TRANS/WP.29/GRE/2002/41
18 July 2002

World Forum for Harmonization of Vehicle Regulations (WP.29)

PROPOSAL FOR DRAFT AMENDMENTS TO REGULATION No. 98

(Headlamps with gas-discharge light sources)

Figure 1:

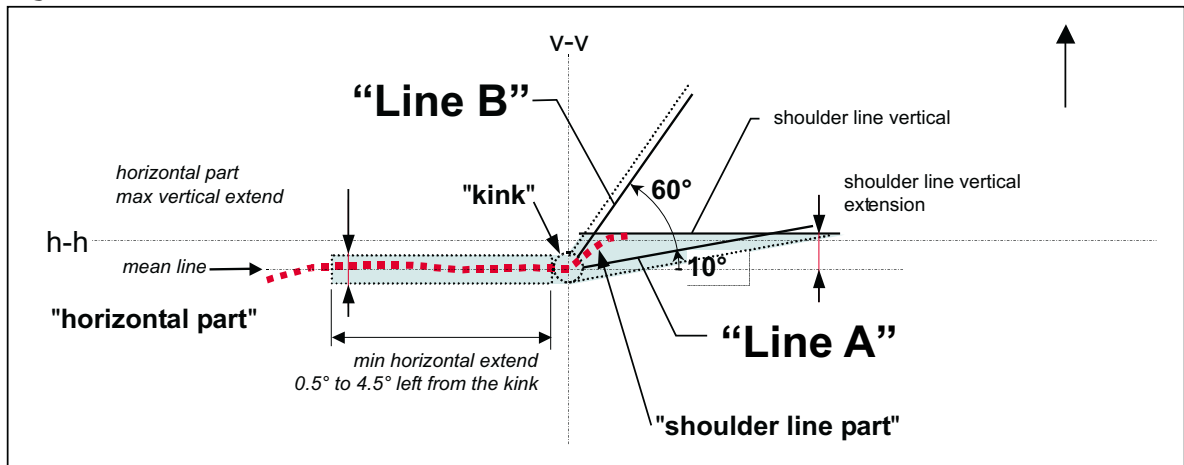
For visual adjustment of the passing beam the cut-off line shall provide a horizontal line for vertical adjustment of the headlamp between 0.5° and 4.5° distant from the v-v-line (see Figure 1), which does not exceed a vertical extend of $\Delta\beta = 0.2$ degree up or down.

Figure 2:

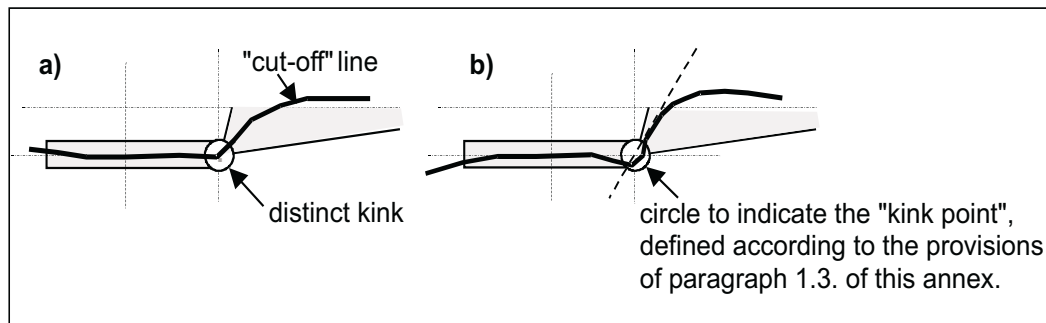
enough edge, that point shall be taken, where the horizontal line through the straight part and the steepest tangential line onto the shoulder part of the cut-off line are crossing (for examples see Figure 2). The "shoulder line part":

- (a) does not extend the tangential line "B" going from the "kink" upwards to the right and being inclined versus h-h by 60° ;
- (b) does not extend the tangential line "A" going from the "kink" upwards to the right and being inclined versus h-h by 10° ;
- (c) has a vertical extension of at least $\Delta\beta = 0.57^\circ$ over a distance of 2° to the left (right hand traffic) and 2° to the right (left hand traffic).

Figure 3:

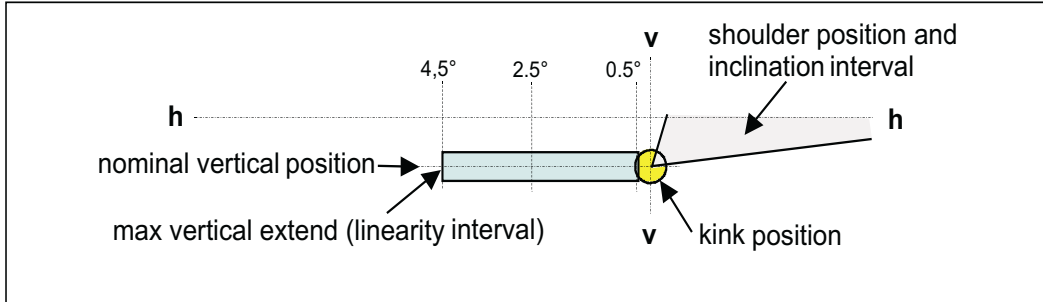
The part of the cut-off line which serves vertical adjustment shall be horizontal between 0.5° and 4.5° distant from the V-V-line. This requirement is deemed to be met when the vertical position of

the inflection points (where $d^2(\log E) / d\beta^2 = 0$) at 1.5° , 2.5° and 3.5° horizontal distance from the v-v-line are located within a band width of $+ 0.2^\circ$ from the nominal vertical position of the cut-off line at 2.5° sideward of the v-v-line, see Figure 3.
